SPARTAN CHASSIS, INC.

CSB06-330-001

CAMPAIGN SERVICE BULLETIN

SUBJECT: Air Supply System- Smart Air Management System (SAMS)
Electronic Control Unit (ECU)

FIG. 3-1

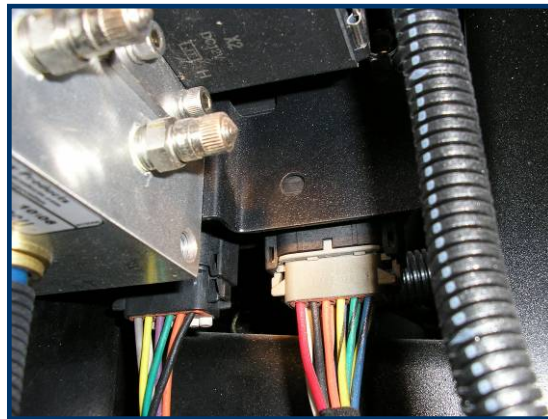
4. Refer to FIG. 3-1. Mark connectors to identify correct location for reassembly. Disconnect cable connections at ECU.
